**RE: WORK PLAN FOR DATA GAP MONITORING WELL INSTALLATION
BULK FUELS FACILITY
SOLID WASTE MANAGEMENT UNIT ST-106/SS-111
KIRTLAND AIR FORCE BASE
EPA ID# NM9570024423, HWB-KAFB-13-MISC**

The New Mexico Environment Department (“NMED”) is in receipt of the Kirtland Air Force Base (“KAFB”) (“Permittee”) *Work Plan for Data Gap Monitoring Well Installation* (“Work Plan”), dated December 20, 2017. The Work Plan proposes activities to be performed at the Bulk Fuels Facility (“BFF”) site, including:

WORK PLAN FOR DATA GAP MONITORING WELL INSTALLATION
 BULK FUELS FACILITY
 SOLID WASTE MANAGEMENT UNIT ST-108/SS-111
 KIRTLAND AIR FORCE BASE, NEW MEXICO

FIGURE 3-1

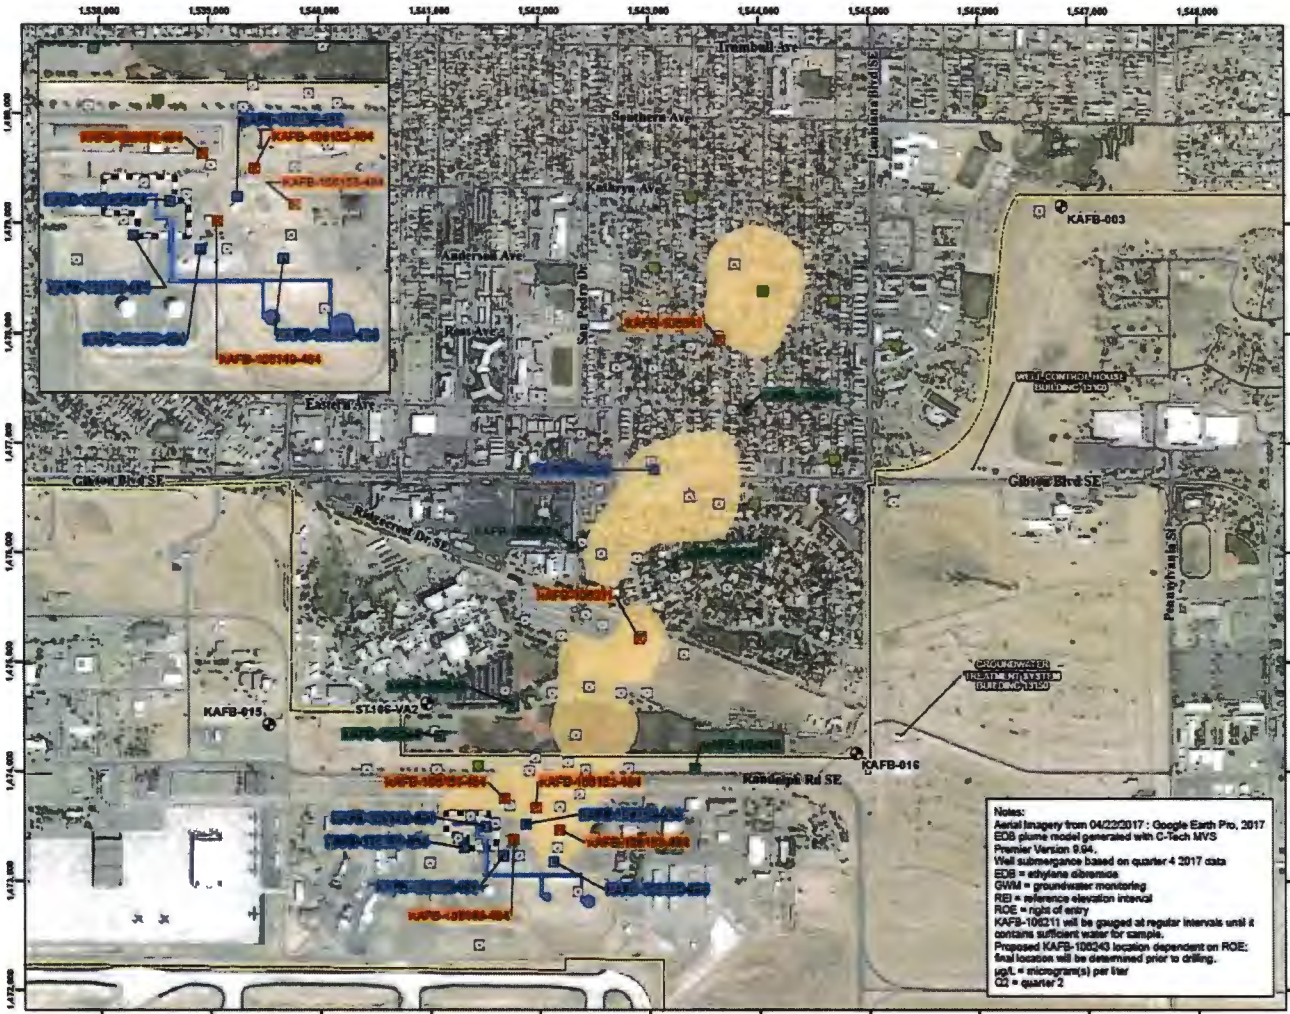
1. The Permittee and NMED have agreed to move well KAFB-106240 to a location east of the VA Hospital supply well, as shown on the attached map. Subject to NMED approval, the Permittee shall propose the specific location, based on accessibility for drilling vehicles and equipment.
